Document ID: 77378094

Service Bulletin

NX 23.00 SU1 available

- This document introduces software update NX 23.00 SU1.

Figure 1

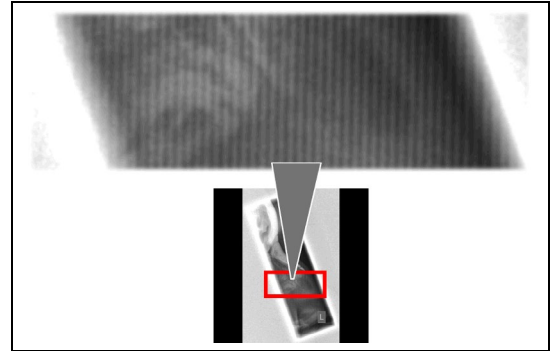
1.5.1 Very sporadic grid lines in the image [PRB2000331]

Symptom Very sporadically grid lines appear in the image, despite a supported anti-scatter grid is used, with the right SID for the selected grid.

Cause An anti-scatter grid is not visible in a saturated area. If parts of the image are saturated, the detection algorithm of the grid line suppression is sometimes not detecting the grid.

Solution Install NX 23.00 SU1 on top of NX 23.00. This contains an improved detection algorithm of the grid lines.

Figure 2

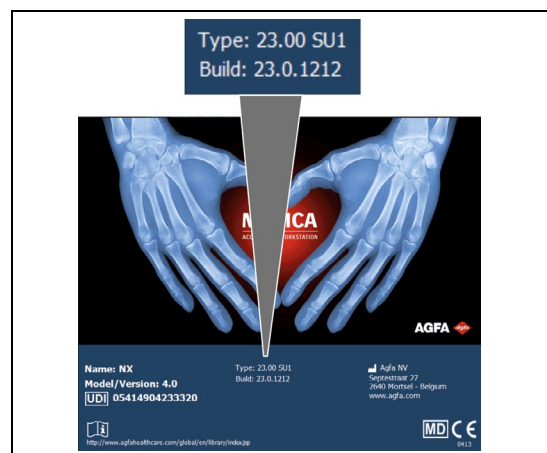
After the NX 23.00 SU1 update, the NX shows **Type 23.00 SU1** and **Build 23.0.1212**.
